Subject: SUNROOF WATER LEAK AFTER HIGH PRESSURE CAR WASH	Bulletin No: 09-014/13
	Last Issued: 05/03/2013

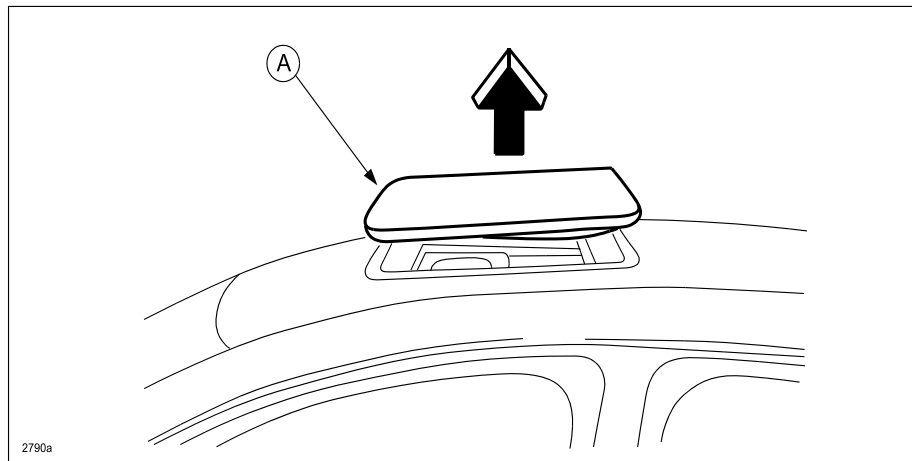
Some customers may experience a water leak from the sunroof after washing the vehicle with a high-pressure car wash system. High pressure water from the car wash may drip from the drip rail and leak into the cabin.

Customers having this concern should have their vehicle repaired using the following repair procedure.

2790a

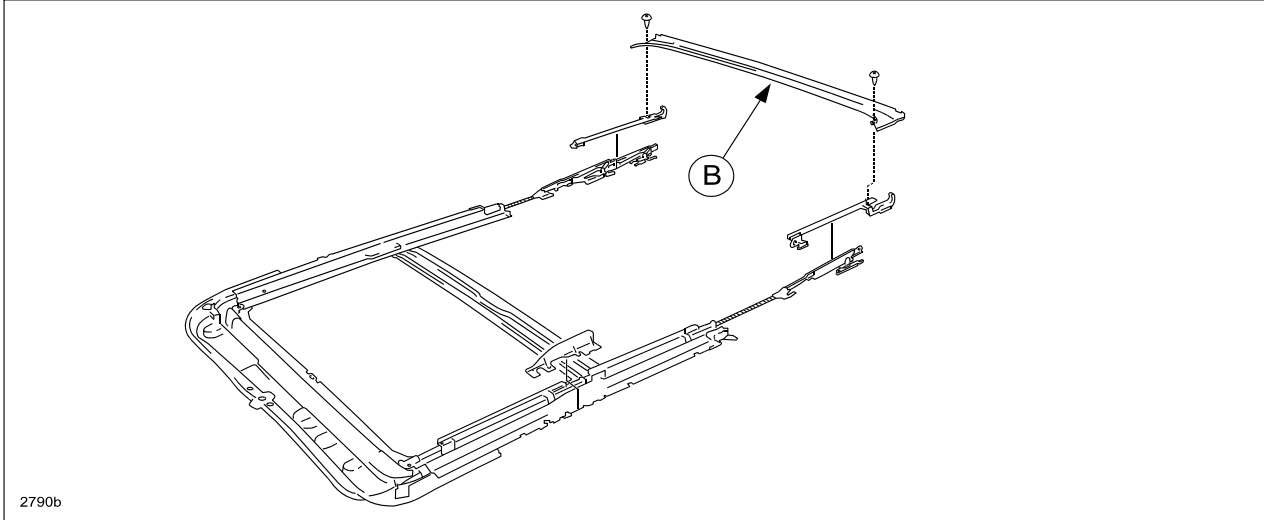
1. Verify customer concern.
2. Remove the sunroof glass panel (A). Refer to MS3 online or Workshop Manual:
 - Mazda6 - (section 09-15 GLASS PANEL REMOVAL/INSTALLATION).
 - CX-5 - (section 09-15 GLASS PANEL REMOVAL/INSTALLATION).
 - CX-9 - (section 09-15 GLASS PANEL REMOVAL/INSTALLATION).

3. Replace the drip rail (B). Refer to MS3 online or Workshop Manual:
 - Mazda6 - (section 09-15 SUNROOF UNIT DISASSEMBLY/ASSEMBLY).
 - CX-5 - (section 09-15 SUNROOF UNIT DISASSEMBLY/ASSEMBLY).
 - CX-9 - (section 09-15 SUNROOF UNIT DISASSEMBLY/ASSEMBLY).

Replace the sunroof drip rail.
